TOWN OF EAGLE REFERRAL RESPONSE SUMMARY REPORT

ISSUED: August 13, 2025

Project Name: Vail Valley Design Center Development Plan and Lot Consolidation (DR25-04 & LLA25-02)

Prepared by: Alyssa Rivas, Planner – Community Development Department

1 SITE PLAN
C1.1 1" = 30'-0"

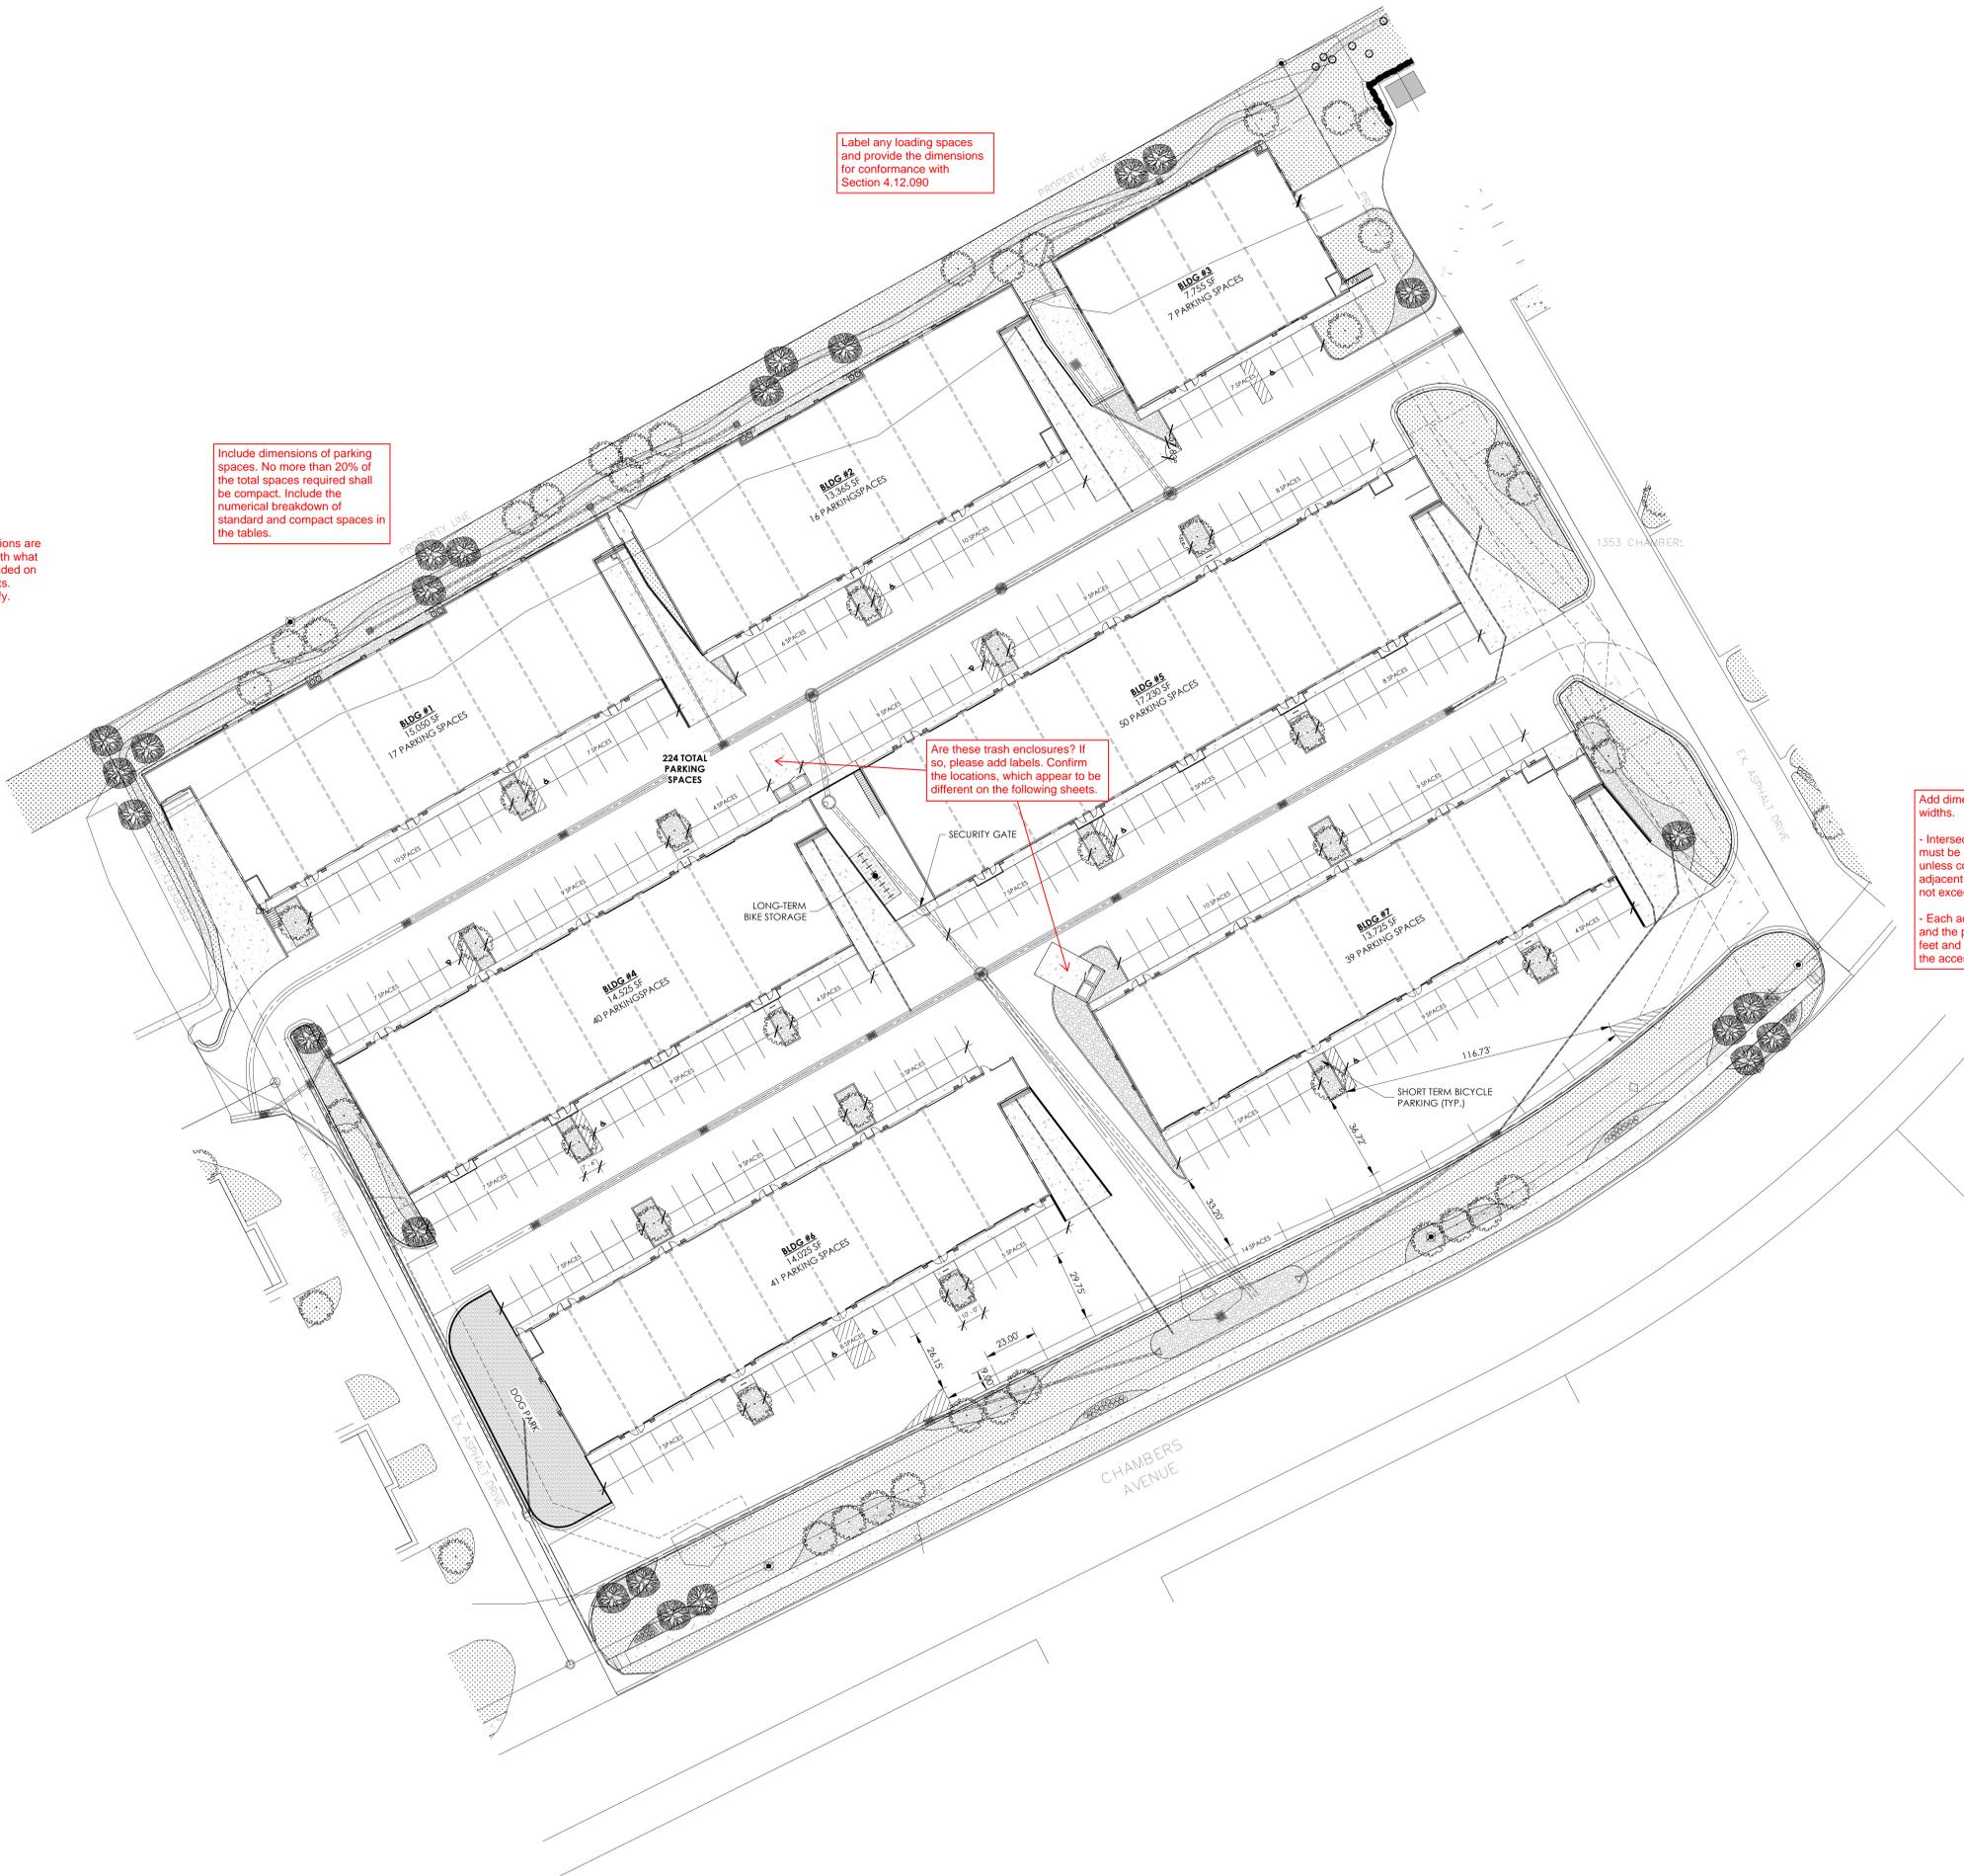
These calculations are inconsistent with what has been provided on following sheets. Revise or clarify.

Include dimensions of parking spaces. No more than 20% of the total spaces required shall be compact. Include the numerical breakdown of standard and compact spaces in the tables.

Label any loading spaces and provide the dimensions for conformance with Section 4.12.090

Are these trash enclosures? If so, please add labels. Confirm the locations, which appear to be different on the following sheets.

Add dimensions for access/driveway/aisle widths.

1 SOUTH ELEVATION
A2.1 1/8" = 1'-0"

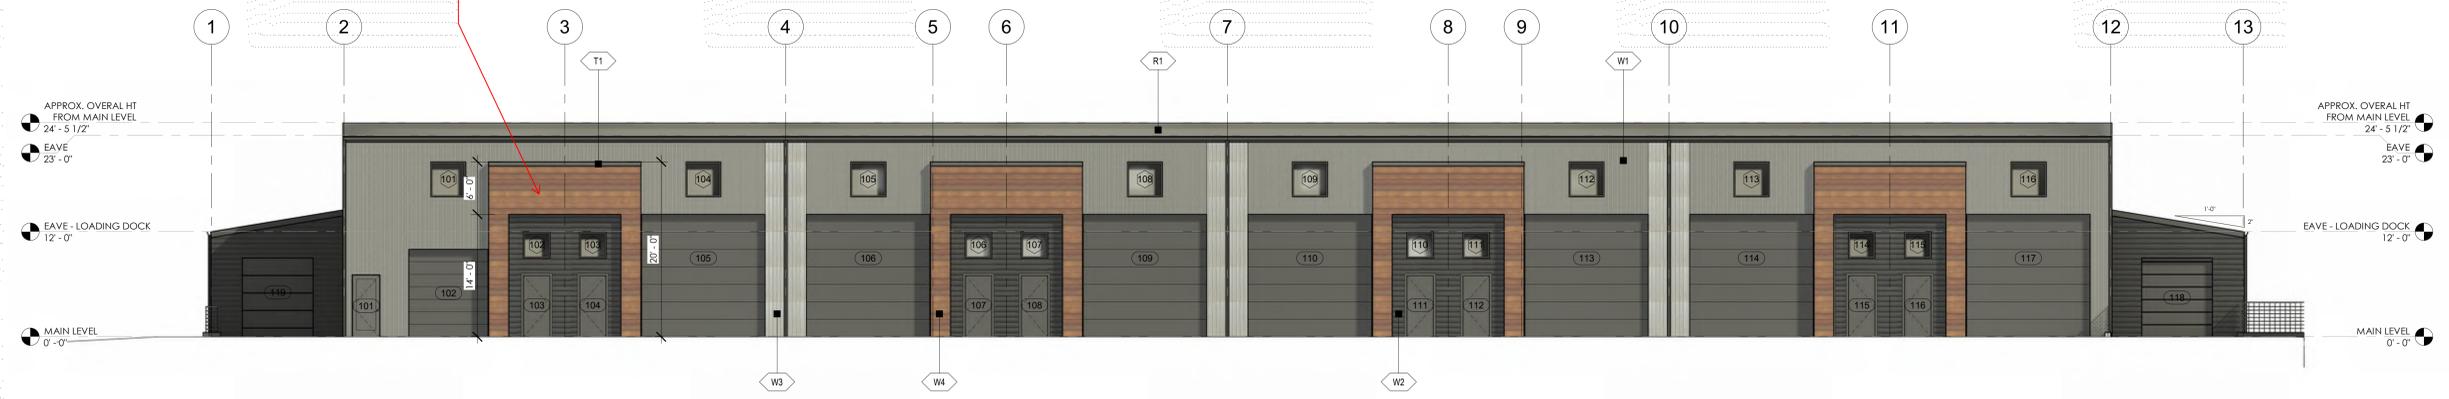
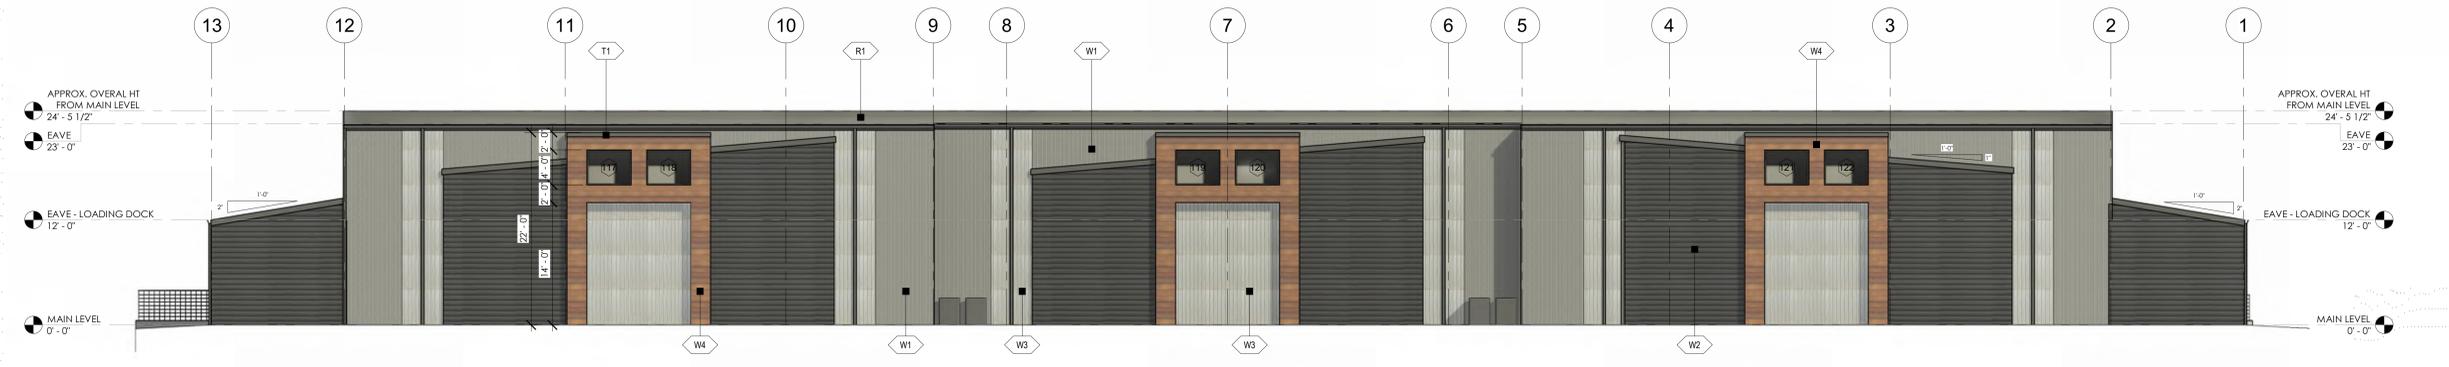
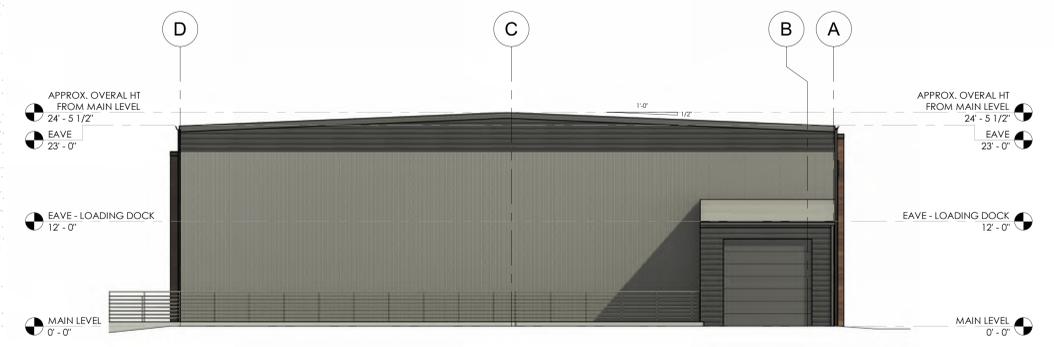
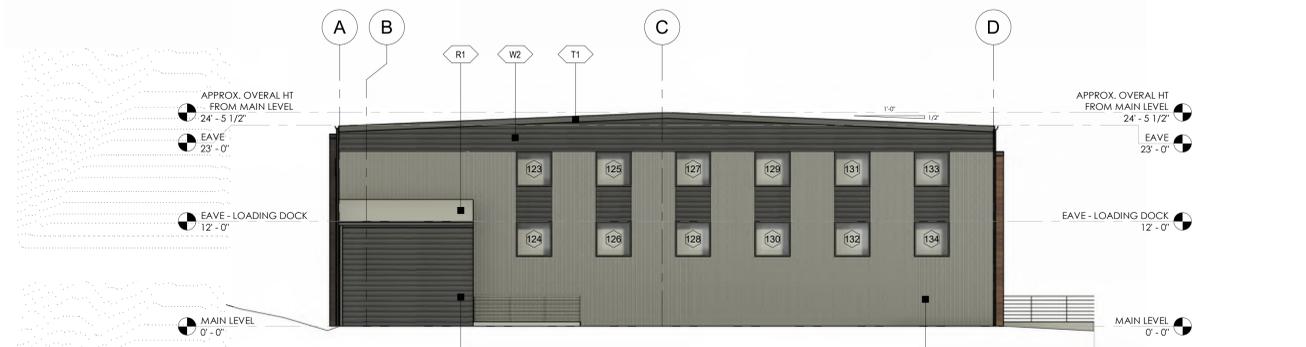
The woodgrain portions of the building appear to be considered the accent walls, which are permitted to be comprised of patinaed or color-treated metal. However, all other primary portions of the building wall are also comprised of metal siding and corrugated panels, which does not comply with this standard. See Sec. 4.10.030.B for permitted facade materials.

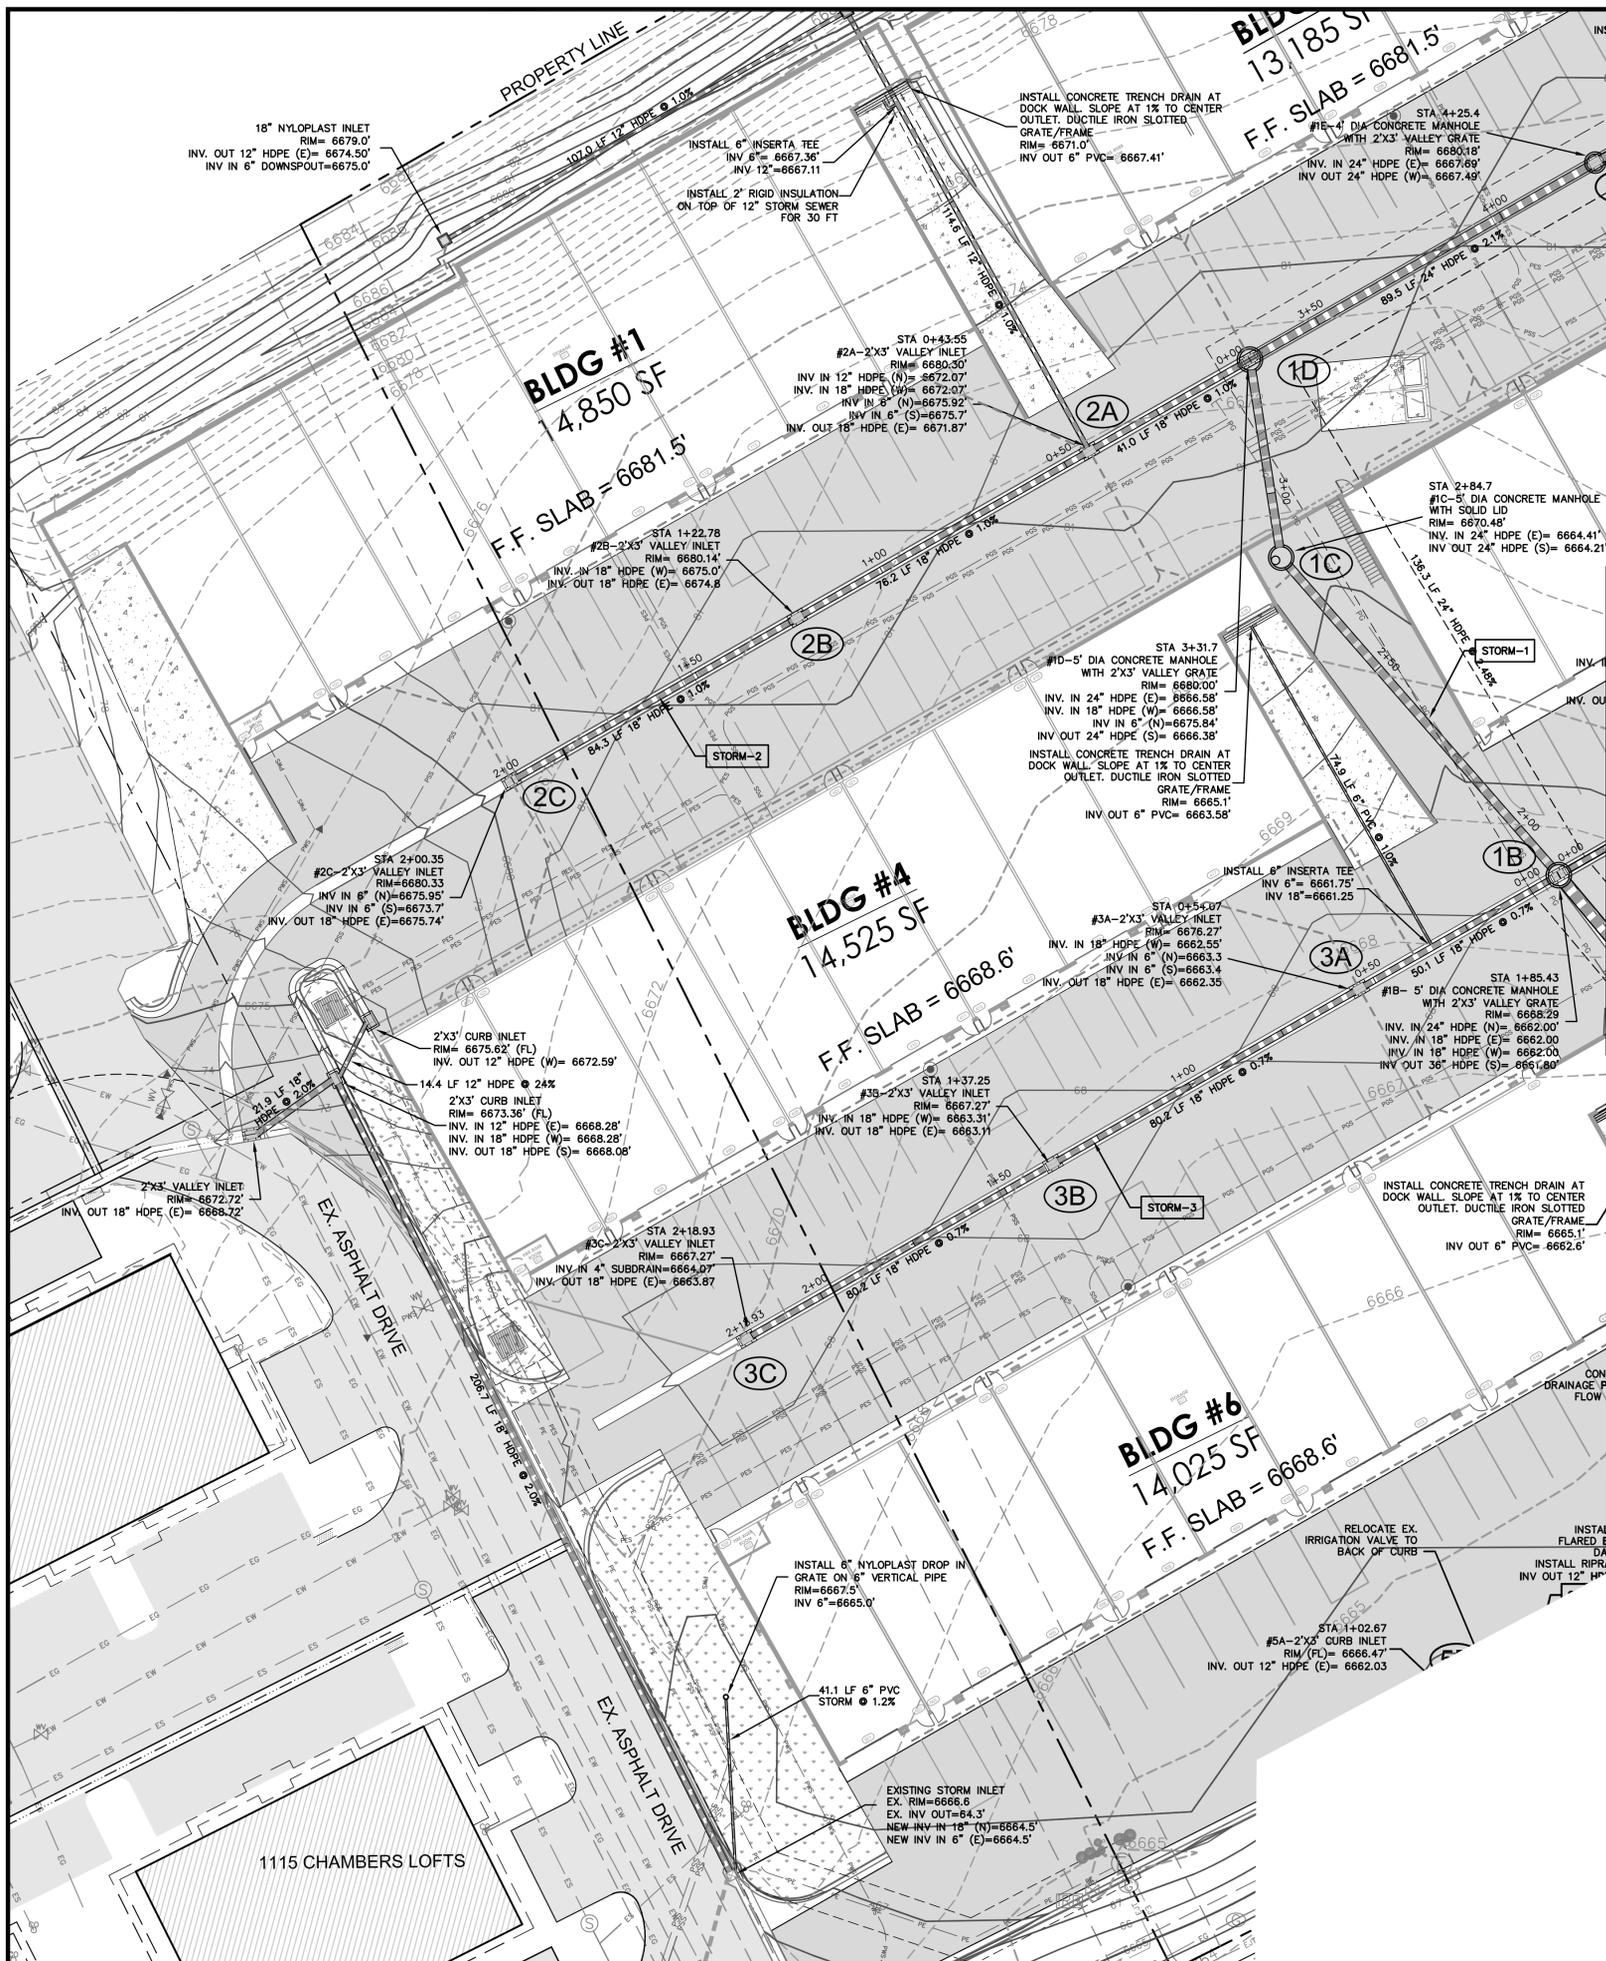
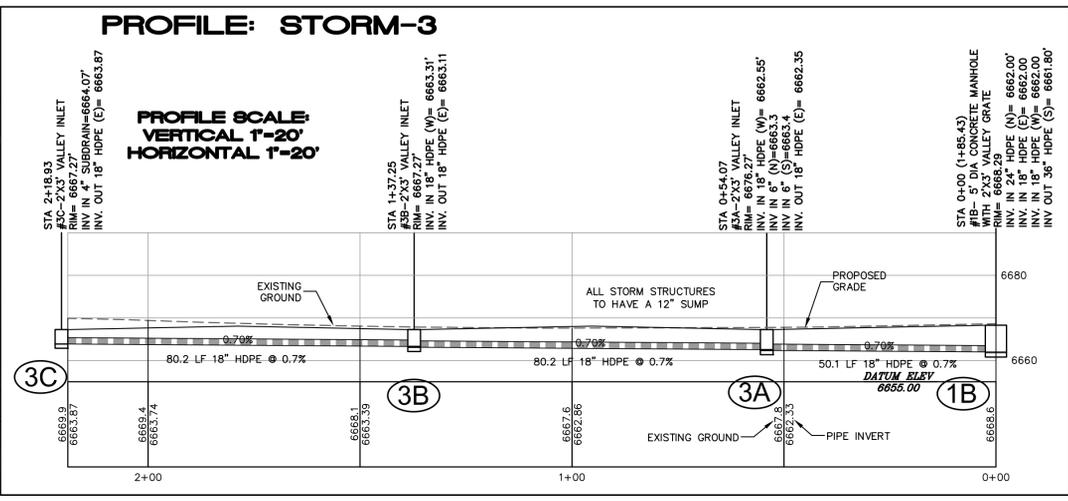
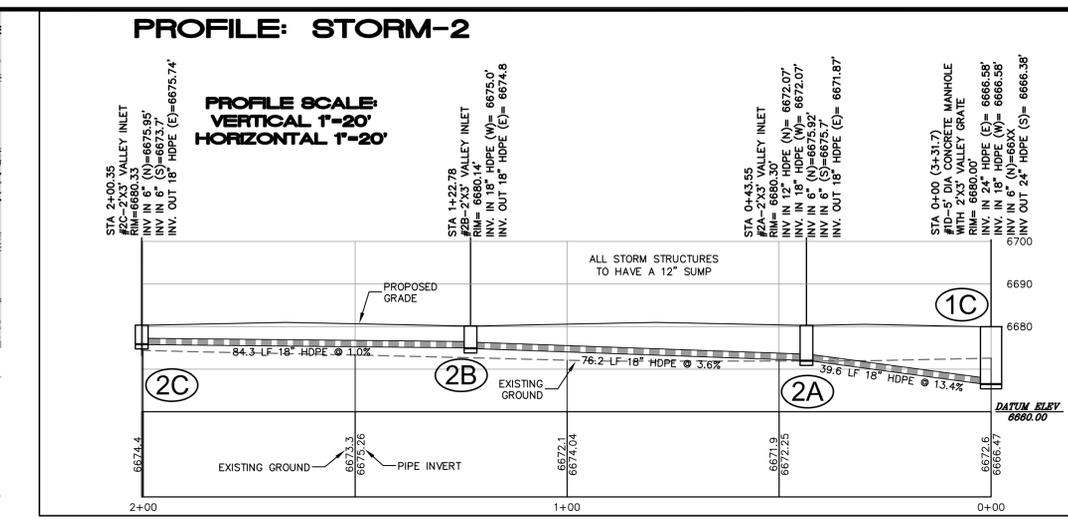
how this section in the plan and drainage report

terminate with headwall or flared section

how is the pond being protected from erosion at the outlets

how much detention is being provided?
